NOTICE OF DECISION
Heritage Center, Building B
Site Plan Review, Type II Review
(2019-010-SPR/SEPA)

CITY STAFF	Anthony Cooper, P.E. La Center City Engineer Naomi Hansen, La Center Associate Planner Eric Eisemann, E ² Land Use Planning, Consulting Planner
REVIEW	Type II Site Plan review and SEPA
RECOMMENDATION	Approval with conditions
DATE	May 2, 2019

Heritage Center Building B Landscape Plan

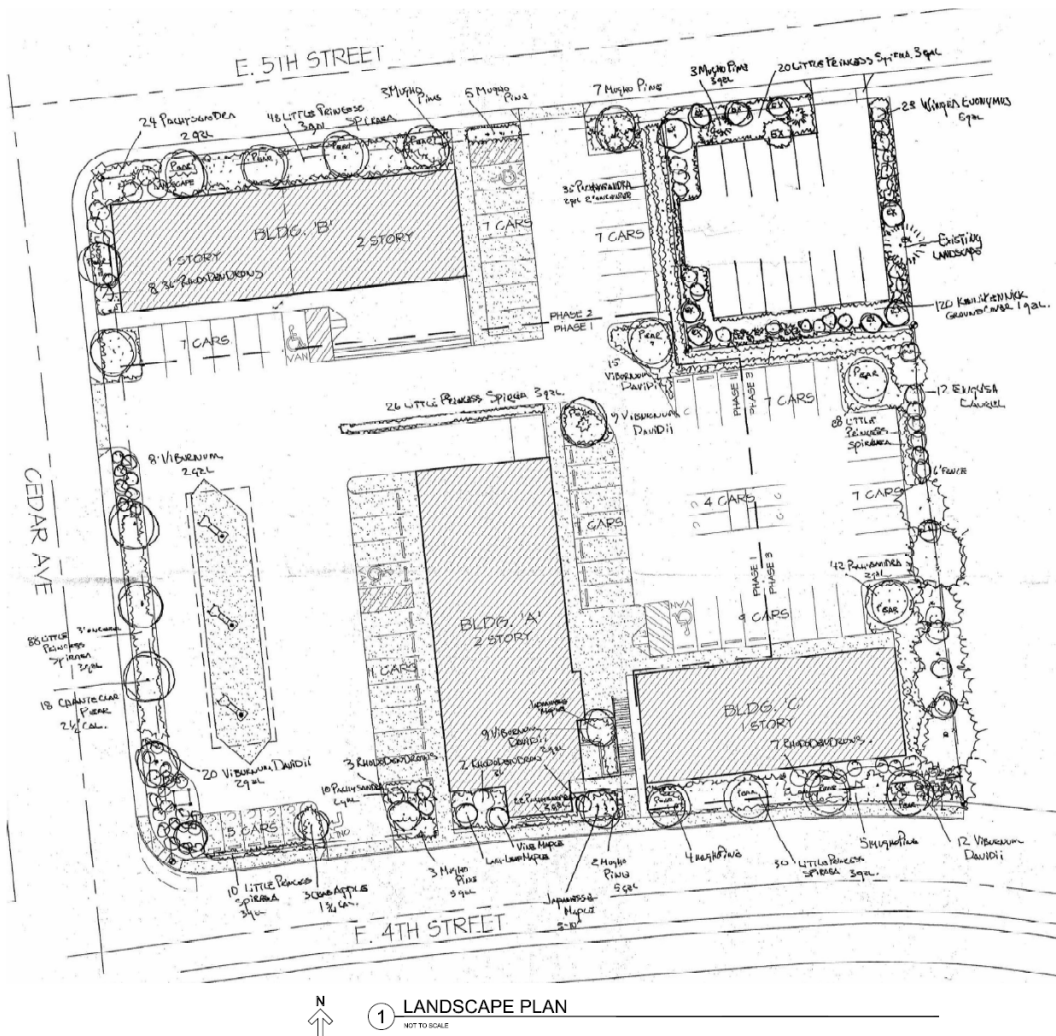
Findings: The applicant provided the following site and landscape plan which are consistent with earlier approvals on-site and with this chapter.

The applicant shall provide site improvements related to fencing, waste handling, parking and landscaping as depicted in Heritage Building B landscaping and site plan figures contained in this decision.
